## Addendum No. 6

Austin Masjid  
800 N Heatherwilde Blvd., Pflugerville, TX 78660  
June 19, 2026

Project Number: 2305

**1 FIRST FLOOR POWER PLAN**  
SCALE: 1/8" = 1'-0"

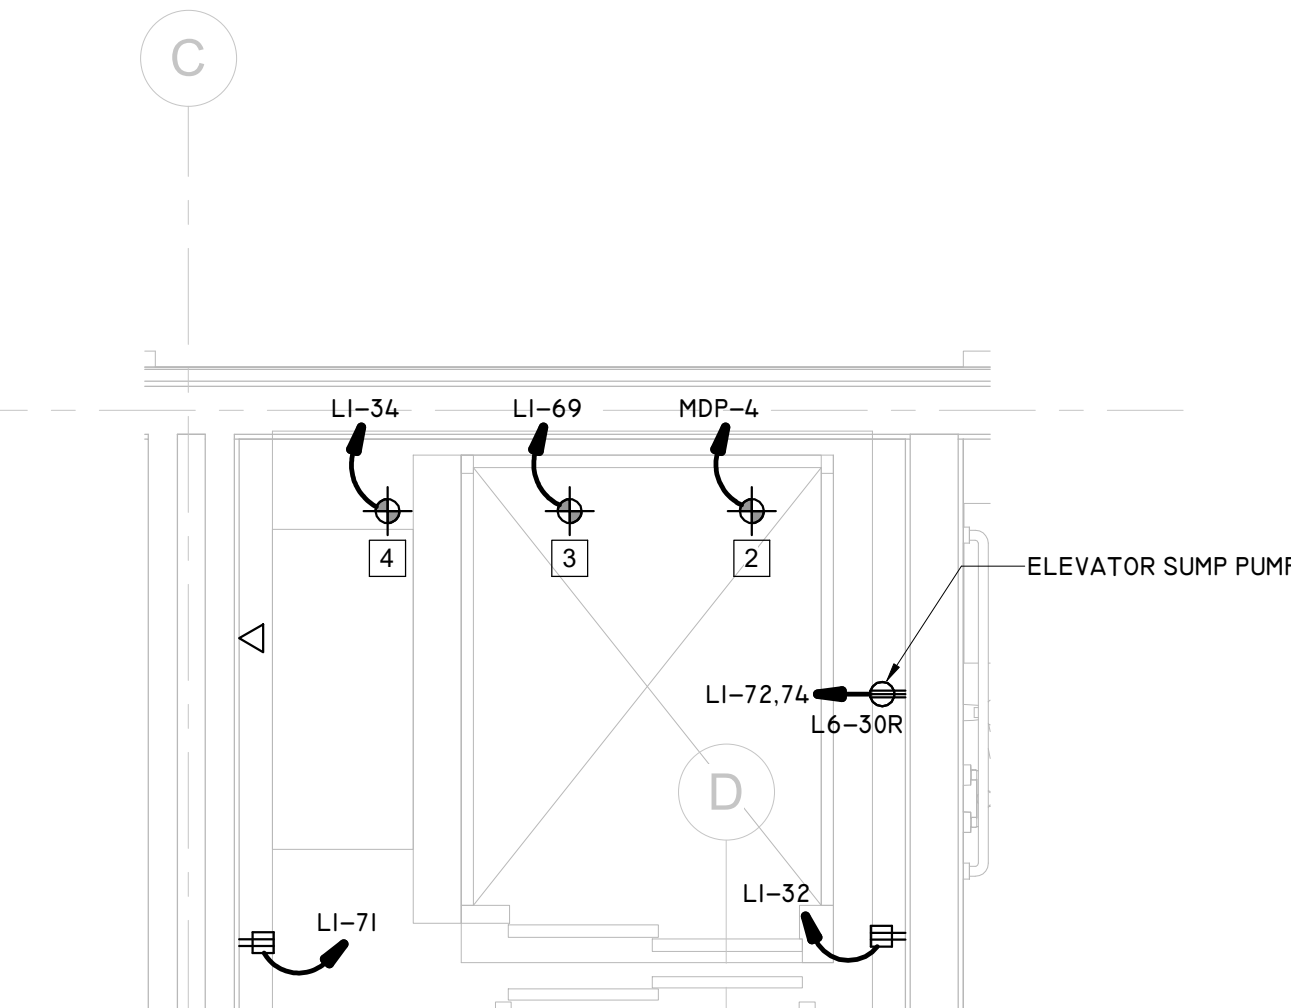
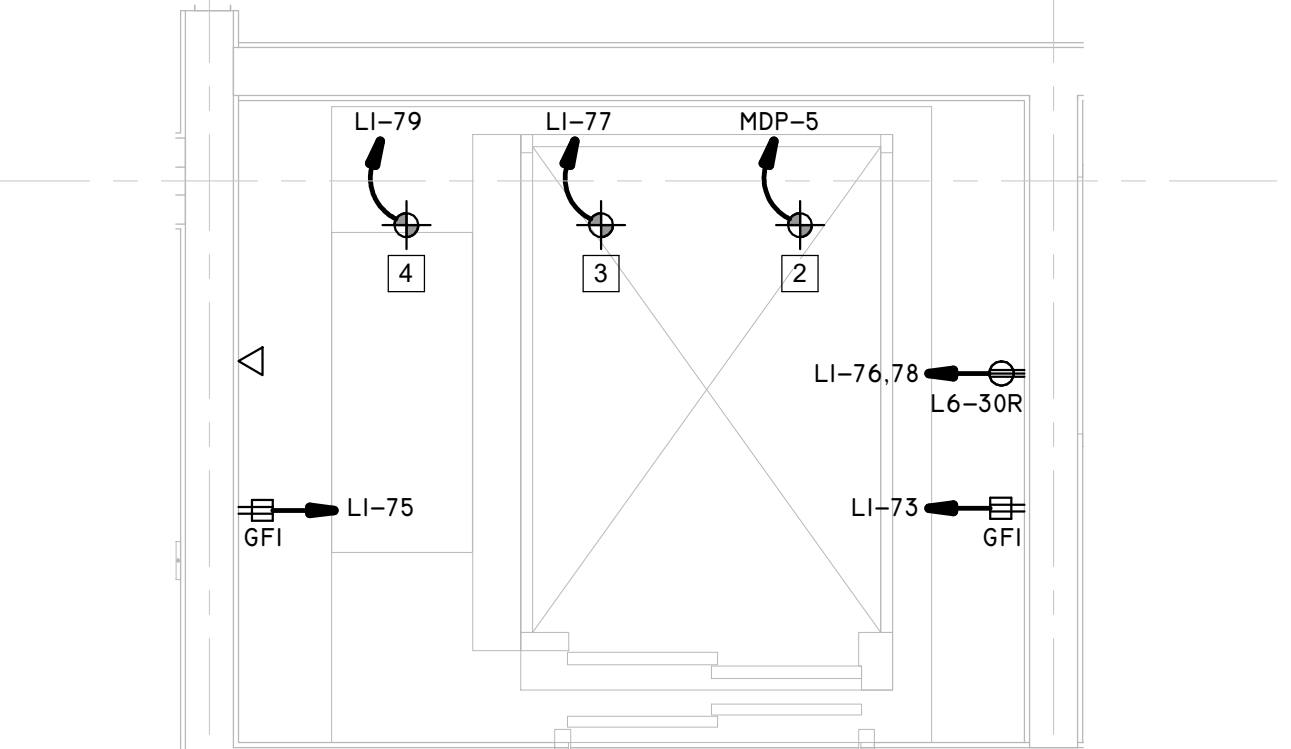
- E1.03      ADDED CIRCUITS FOR THE KITCHEN COOLER AND FREEZER TO PANEL "H1" SCHEDULE. ADDED CIRCUIT FOR EDF-1 TO PANEL "L1" SCHEDULE.
- E2.00      ADDED KEYED NOTE 5, CIRCUITS FOR THE KITCHEN COOLER, KITCHEN FREEZER, AND ELECTRIC DRINKING FOUNTAIN (EDF-1) TO FIRST FLOOR POWER PLAN
- E5.01      ADDED DETAILS FOR DUCT BANK, POLE BASE, POLE LIGHT WIRING DIAGRAM AND QUAZITE PULL BOX.
- E5.02      ADDED SHEET E5.02 WITH DETAILS FOR LIGHTING CONTACTOR, CONCRETE ENCASE DUCT BANK, EMERGENCY BALLAST, TRENCHING, DISCONNECT SWITCH, CONDUIT RACK, AND CONDUIT WALL PENETRATION.

**P3.01**

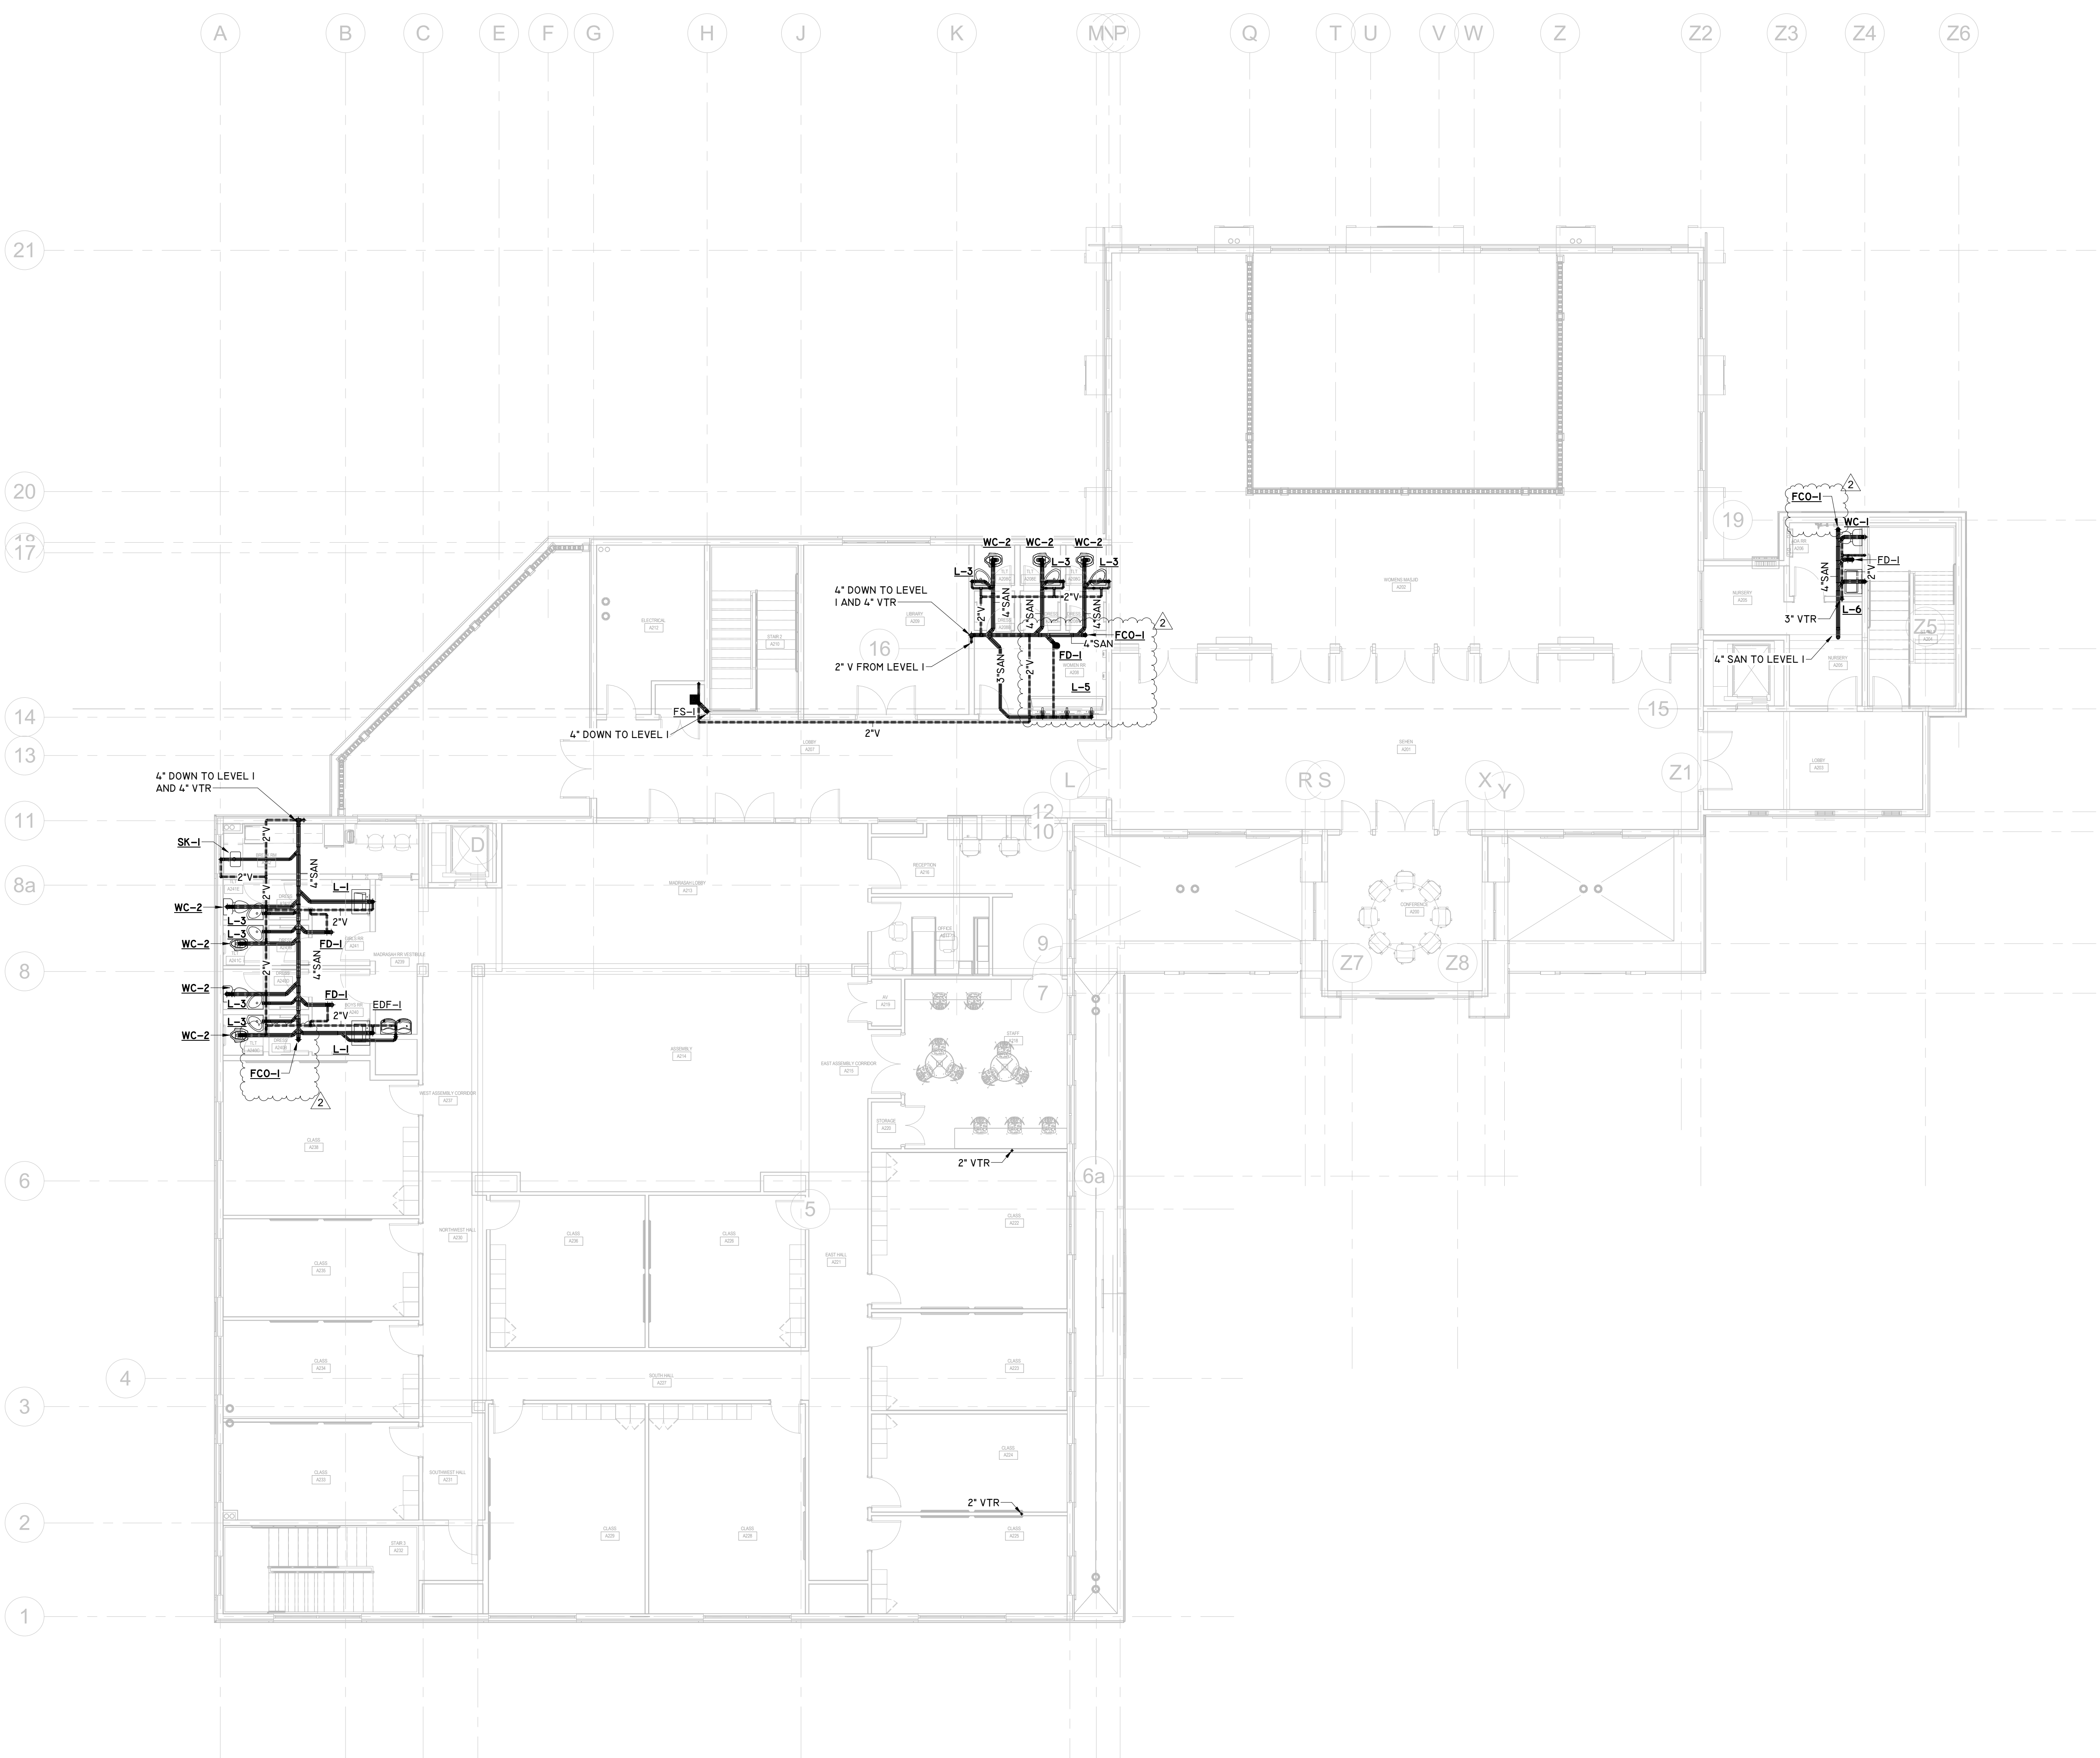
P3.01 ADJUSTED PIPING, ADJUSTED TAGS. ADDED NOTES.

SHEET NUMBER  
**P4.00**

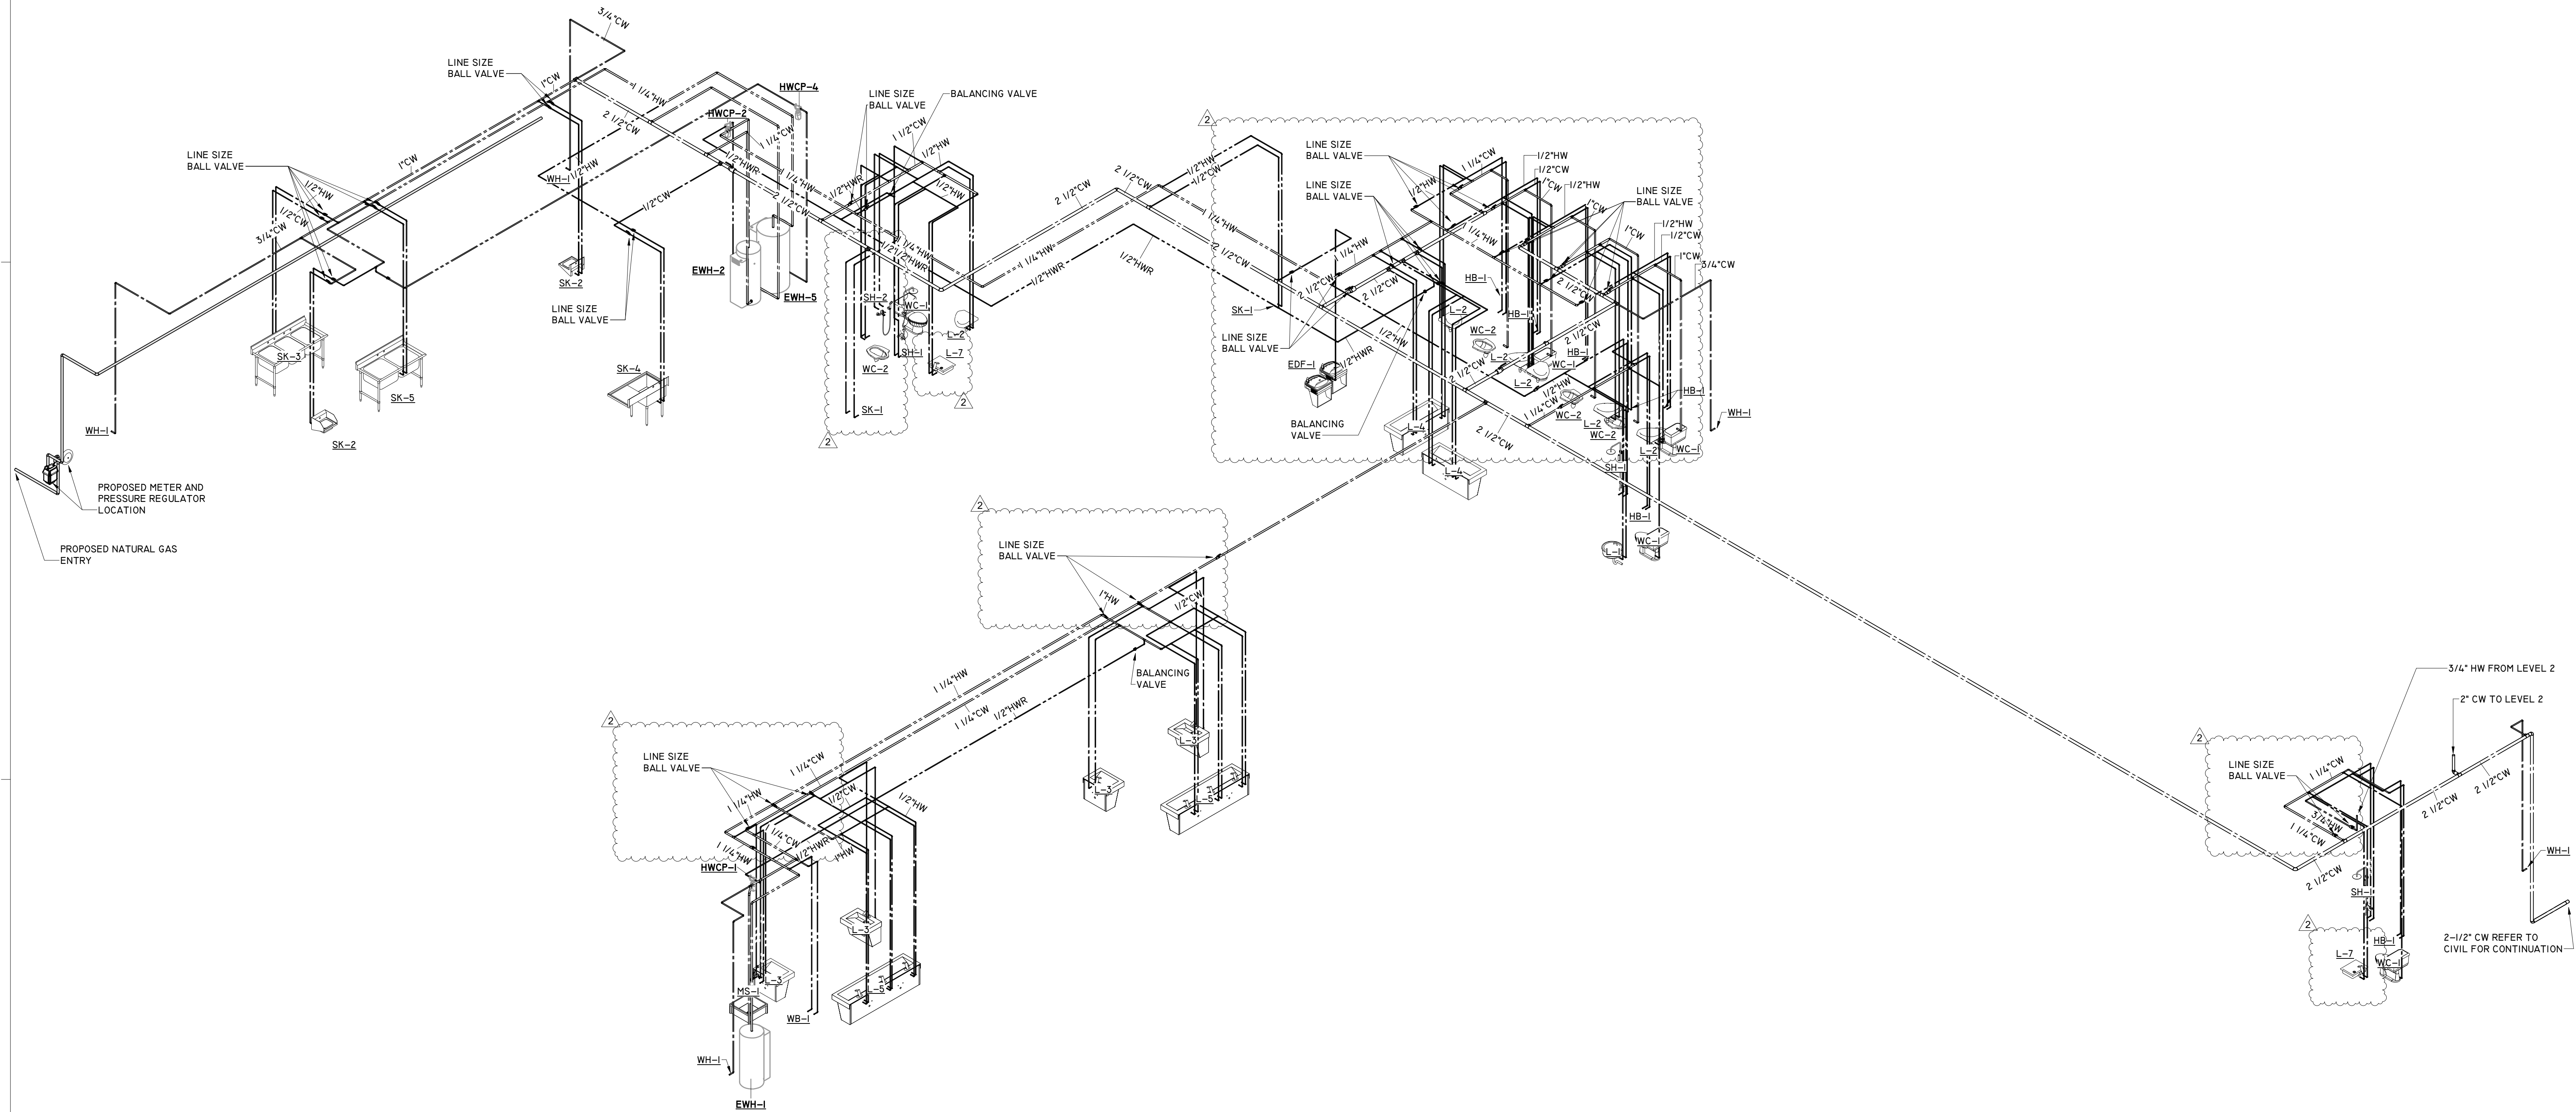
P4.00 ADJUSTED TO MATCH FLOOR PLAN. ADJUSTED TAGS
